## Agenda Item # 7

SUB-003551-2025

Farill Place Subdivision

## FARILL PLACE SUBDIVISION

## DETAIL SITE PLAN

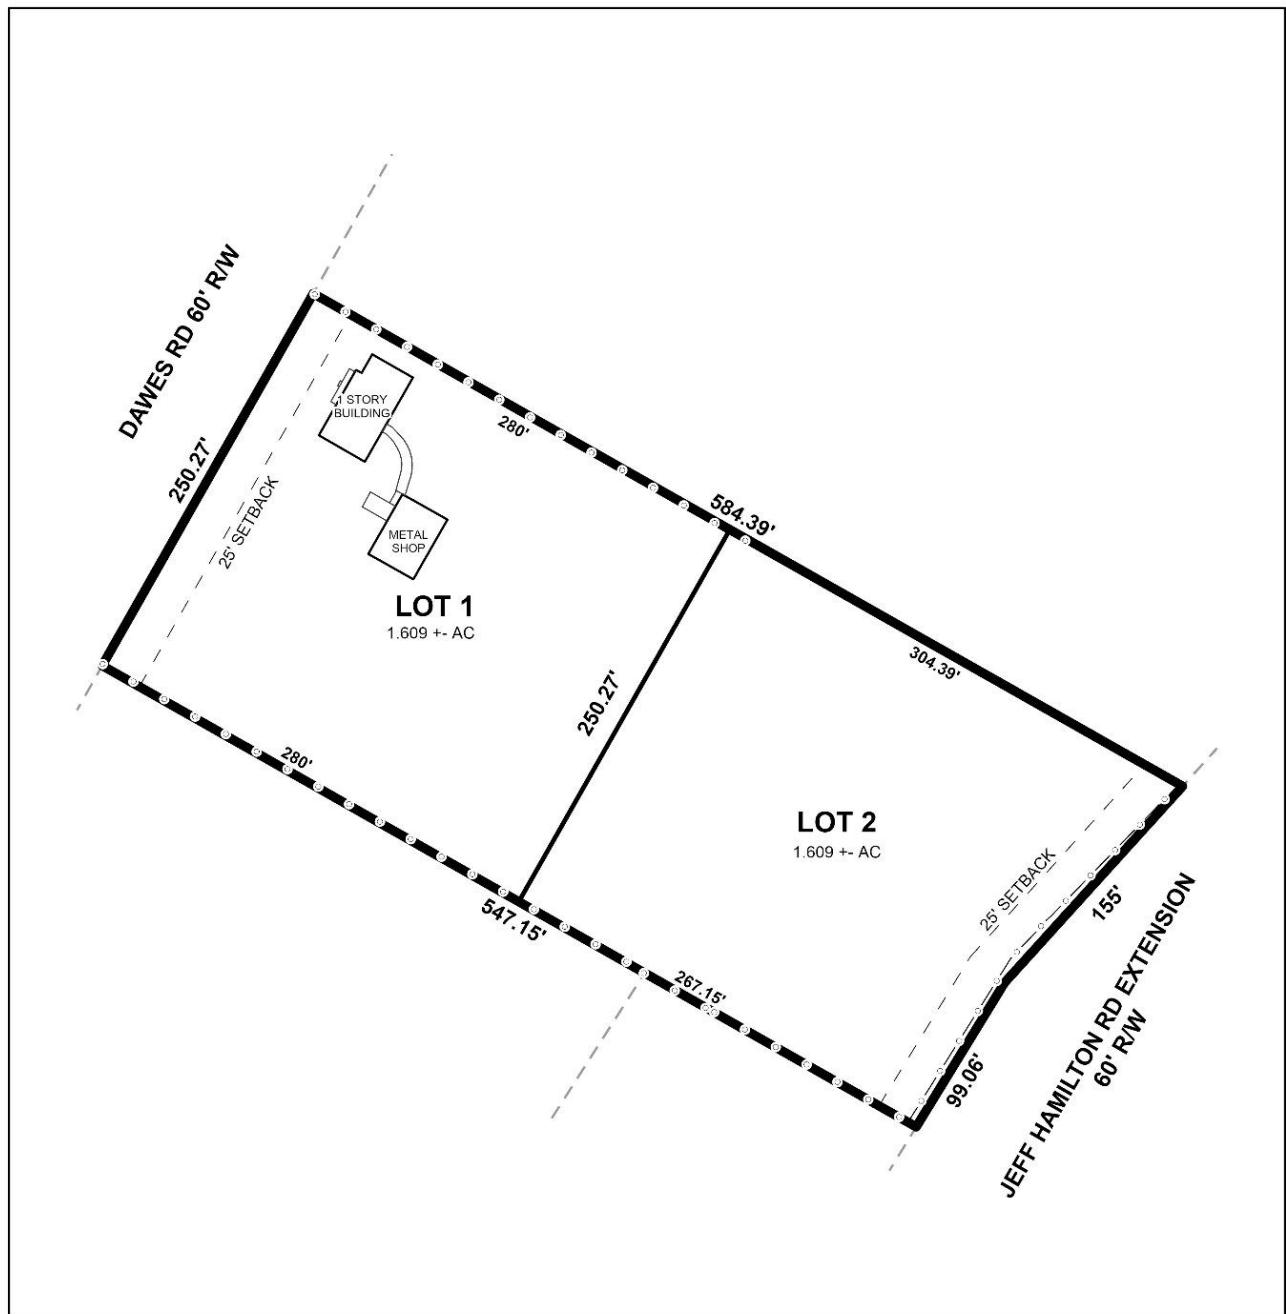
The proposed lots have frontage on Dawes Road and Jeff Hamilton Road Extension. Dawes Road is a Minor Arterial street requiring a 100-foot right-of-way at this location. Jeff Hamilton Road Extension is a minor street without curb and gutter requiring a 60-foot-wide right-of-way at this location. Sufficient right-of-way is depicted along Jeff Hamilton Road Extension on the preliminary plat, but not along Dawes Road. As such, if approved, the plat should be revised to illustrate dedication sufficient to provide 50-feet from the centerline of Dawes Road.

Finally, the plat illustrates the required 25-foot front yard setback along both street frontages, in accordance with Article 2, Section 64-2-14.E. of the UDC and Section 6.C.8. of the Subdivision Regulations. However, it should be noted that, if dedication is required along Dawes Road, the existing house will encroach on this setback. As such future development may require compliance with the setback requirements unless a variance is obtained from the Board of Zoning Adjustment. In any case, the front yard setback should be retained along both street frontages on the Final Plat, adjusted for any required dedication.

1. Revision of the plat to illustrate dedication sufficient to provide 50 feet from the centerline of Dawes Road;

2. Retention of the right-of-way along Jeff Hamilton Road Extension, as depicted on the preliminary plat;
3. Retention of the lot sizes in both square feet and acres, or the provision of a table on the Final Plat providing the same information, adjusted for any required dedication;
4. Retention of the required 25-foot front yard setback along all street frontages, in compliance with Article 2, Section 64-2-10.E. of the UDC and Section 6.C.8. of the Subdivision Regulations, adjusted for any required dedication;
5. Compliance with all Engineering comments noted in this staff report;
6. Placement of a note on the Final Plat stating all Traffic Engineering comments noted in this staff report;
7. Compliance with all Urban Forestry comments noted in this staff report; and,
8. Compliance with all Fire Department comments noted in this staff report.
